National Committee on Uniform Traffic Control Devices

NCUTCD Proposal for Changes to the Manual on Uniform Traffic Control Devices

TECHNICAL COMMITTEE: Bicycle Technical Committee
ITEM NUMBER: 18-BIK-06
TOPIC: Bicycle Detector Symbol Marking
ORIGIN OF REQUEST: NCUTCD Bicycle Technical Committee
AFFECTED SECTIONS OF MUTCD: Sections 9C.05

82 **Figure 9C-7. Bicycle Detector Pavement Marking**
 83 **[Add the following to the existing symbol:]**

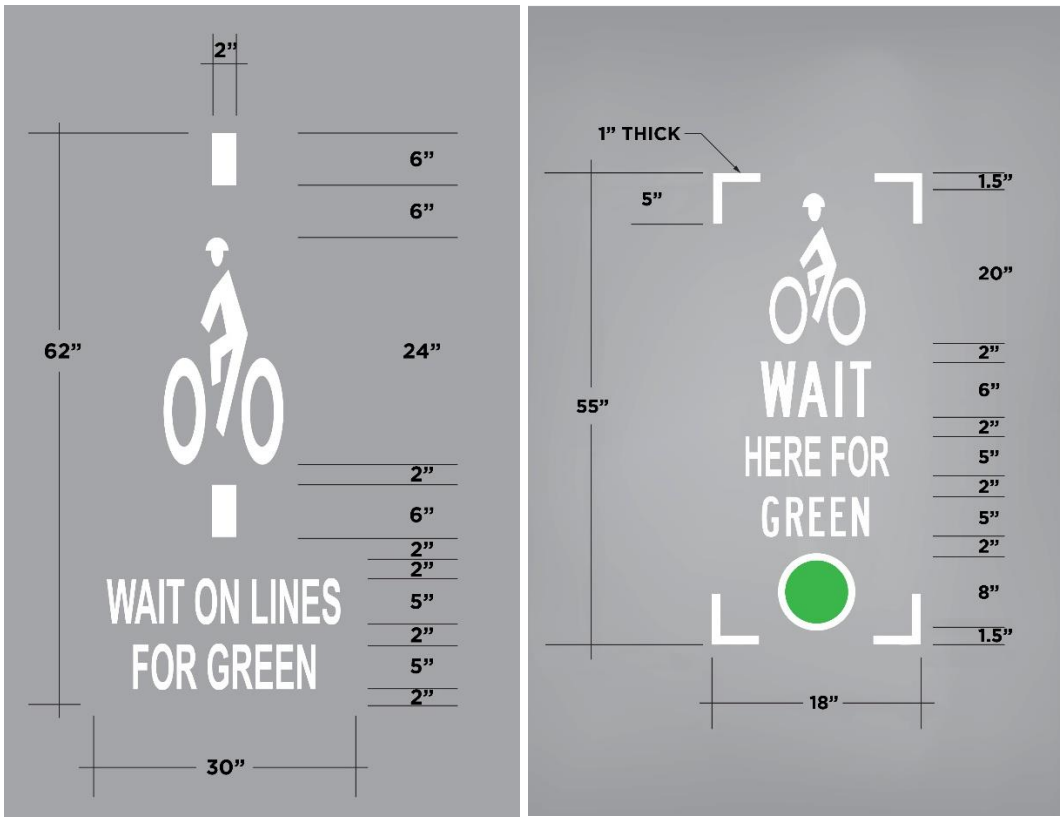
74 01 A symbol (see Figure 9C-7, 9C-7A or 9C-7B) may be placed on the pavement indicating the
75 optimum position for a bicyclist to actuate the signal. Any other appropriate similar symbol in a
76 traffic signal face can be used to replace the green circle identified in Figure 9C-7B, such as a
77 bicycle symbol or green arrow.
